**COUNTY OF RIVERSIDE**  
**GATE AND FENCING PROJECT AT HIGHGROVE FIRE STATION #19**  
**RFB# EDARC-069**

**ADDENDUM NO. I**  
**DECEMBER 04, 2018**

**ADDENDUM NO. I**  
**TO RFB # EDARC-069**

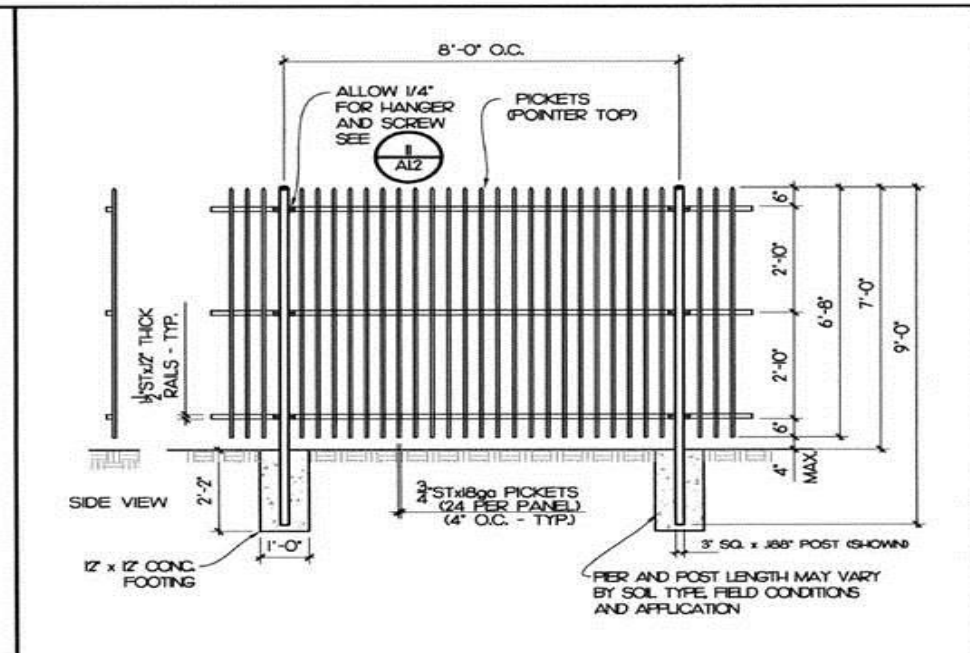
**Question #5:** Gate operator must have a "mouse proof enclosure" see specifications. There are currently no specifications in any of the contract documents regarding the gate operator other than it being 1 HP and having a mouse proof enclosure.

**County of Riverside Answer:** Cover that comes with gate operator unit is acceptable. See spec section 32 3111 / 2.3 / a.

4.0 Additional Information

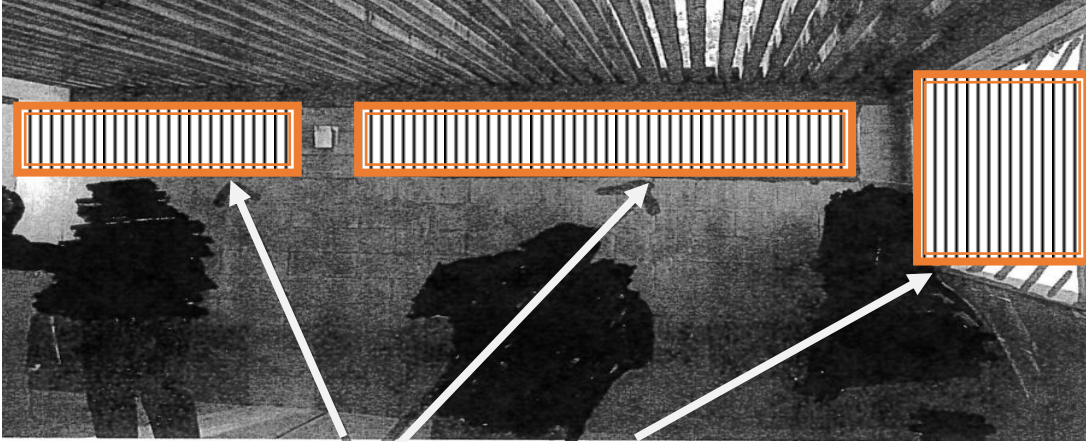
a. Provide fence in-fill similar to fencing in the three areas marked.

Gate Safety

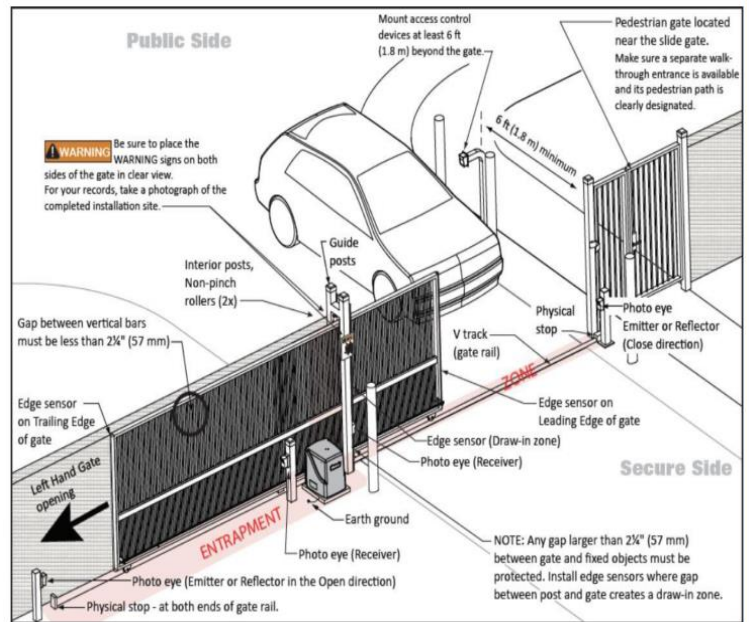
5.0 UL 325 7<sup>th</sup> Edition Requirement – Contractors are required to comply.

Monitoring of external entrapment protection sensors is required for all automated gate operators manufactured after January 11, 2016. The latest revision, effective August 1, 2018, clarifies and elaborates on these requirements.

- Slide gate operators require two external entrapment protection sensors to operate, one in each direction of travel. Sensors can be either contact (edge sensor) or non-contact(photo eye).

- Swing gates require two external entrapment protection sensors, either contact (edge sensor) or non-contact (photo eye), unless there is no entrapment risk in one direction.

- The photo eyes or edge sensors you install must be approved for use with the specific gate operator installed. Sensors proven acceptable are described in the gate operator's installation manual.

- HySecurity publishes an up-to-date table of the tested and approved photo eyes and edge sensors.
- UL 325 sets the MINIMUM standard of safety. You must also verify that the gate site complies with ASTM F2200. Survey site, usage class, gate type and other conditions. Design and install appropriate external entrapment protection sensors that address all potential entrapment zones.

- Above is the UL Standard for automated gate installation and the diagram as to how the safety devices work. This is required for people. The "edge sensors" are contact sensors which activate after an object or person is struck. The "Photo Eye" is a non-contact sensor. They activate prior to the gate striking an object or person by detecting anyone or thing that is in the path of the gate closing or opening. Again this is required for the protection of people. This system pertains to all Fire Stations not just 54.
